**BEFORE INDEPENDENT HEARING COMMISSIONERS APPOINTED
BY THE WAIMAKARIRI DISTRICT COUNCIL**

IN THE MATTER OF Submissions and Further Submissions on
the Proposed Waimakariri District Plan by
Momentum Land Limited and **Mike
Greer Homes NZ Limited**

**EVIDENCE OF JOHN-PAUL BARRINGTON CLARKE
ON BEHALF OF MOMENTUM LAND LIMITED
AND MIKE GREER HOMES NZ LIMITED
STREAM 10A – AIRPORT NOISE ISSUES**

DATED 2 FEBRUARY 2024

Figure 1. Results from the 2014 SoNA study. The new UK dose-response curve (blue line) compared with the curve derived by Miedema and Oudshoorn 2001 (Miedema and Vos 1998)

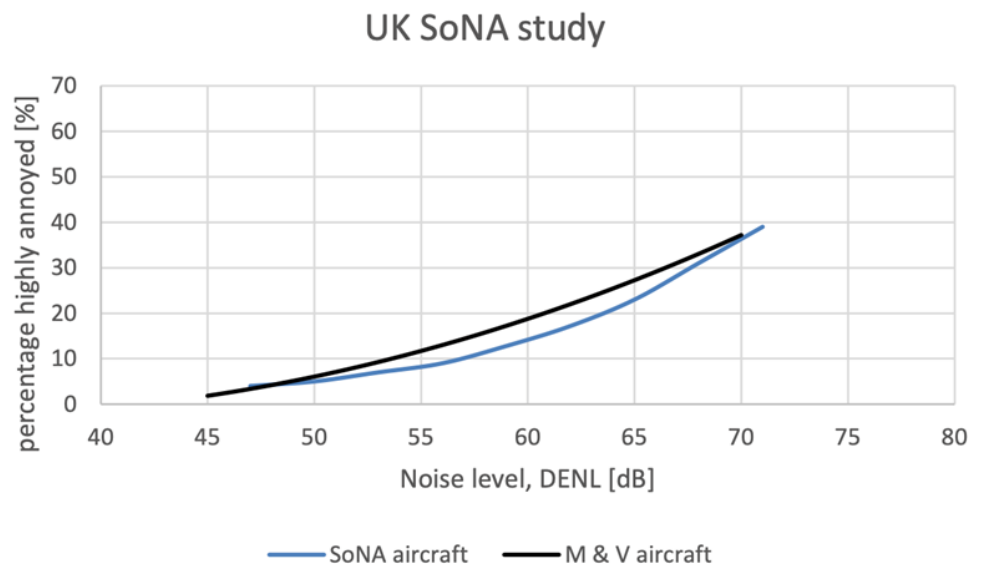
63 In the summer of 2014, UK authorities conducted a survey on aircraft noise annoyance referred to as SoNA – Survey of Noise Attitudes. The objectives were to either confirm the existing or to establish new national dose-response curves for the United Kingdom. Face-to-face interviews were conducted at 9 large airports in England, addressing 2000 residents exposed to aircraft noise levels above $LA_{eq,16h} = 51$ dB. A dose-response function showing the prevalence of highly annoyed residents as a function of the chosen noise index was derived by conventional regression techniques (UK CAA, 2021). The sixteen-hour day equivalent level can be converted to DENL using the conversion tables proposed by Brink et al. (2017). The SoNA dose-response curve indicates a slightly smaller prevalence of annoyance than the curve derived by Miedema and Oudshoorn as shown in Figure 2. When the confidence intervals are taken into account, the two curves must be considered equal. In other words, for a given noise exposure in 2014, people in the UK seem to be equally annoyed by aircraft noise than what was predicted by the dose-response curve presented by Miedema and Oudshoorn (2001). This last curve is based on surveys going back to the 1960s.

64 In other words, the annoyance response seems to have remained stable over a period of 50 years, and no temporal increase can be observed.

Figure 2: Lateral noise levels of commercial jet aircraft

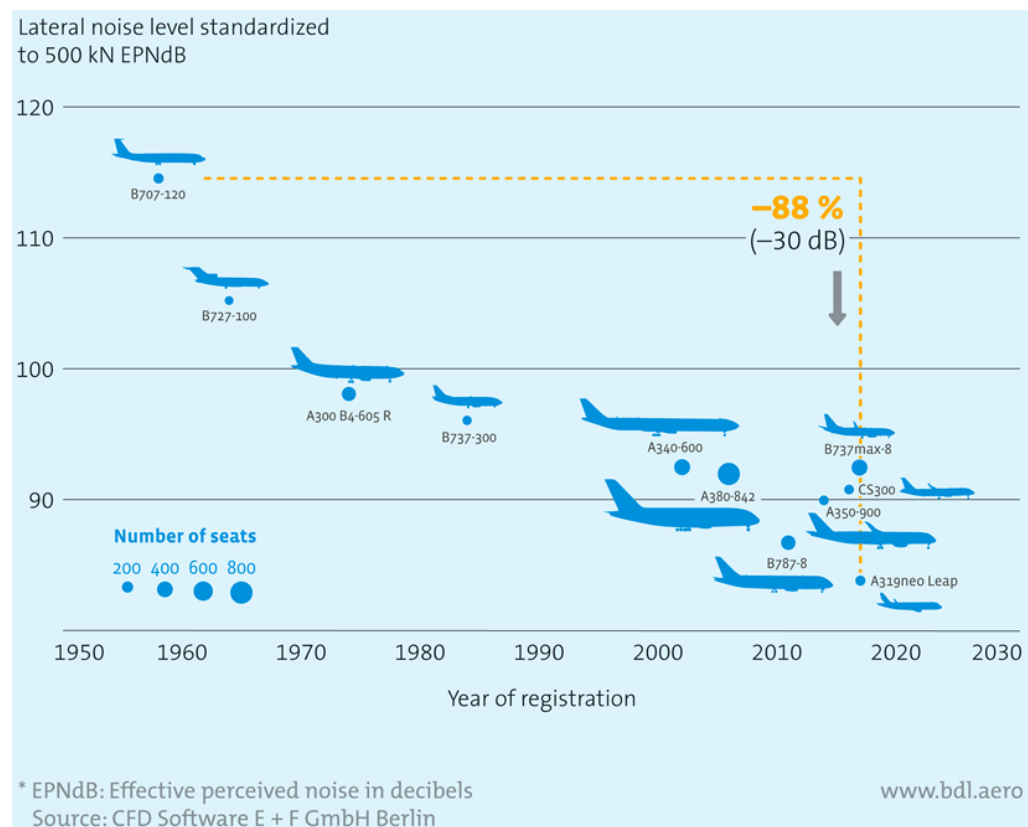
- 84 It is not reasonable to assume that the next generation of single-aisle aircraft will have the same source noise characteristics as the current generation of single-aisle aircraft.
- 85 Over a 60-years period commencing with the certification of the B707-200 in 1957, there has been a significant (approximately 30 dB) reduction in the lateral noise level (in EPNdB) of aircraft (see Figure 2).

- 86 This 30 dB reduction is significant because the lateral noise level has been shown to be the best predictor of the noise impact around airports.
- 87 While it is true that there are diminishing returns overall with respect to the reduction in lateral noise of aircraft, i.e., an exponential curve with a negative exponent has a higher r^2 (a measure of the goodness of fit) than a linear curve with a negative slope, the next generation of single-aisle aircraft will likely be at least 5 dB quieter than the current generation of single-aisle aircraft.

- 88 This assertion is supported by a simple comparison of the 727-100, 737-300, and the A319-neo Leap.
- 89 These three aircraft have similar seating capacities, and the best fit curve though those three points for these aircraft in Figure 2 would be a straight line, indicating that there are likely to be substantive improvements in the next generation of single-aisle aircraft.
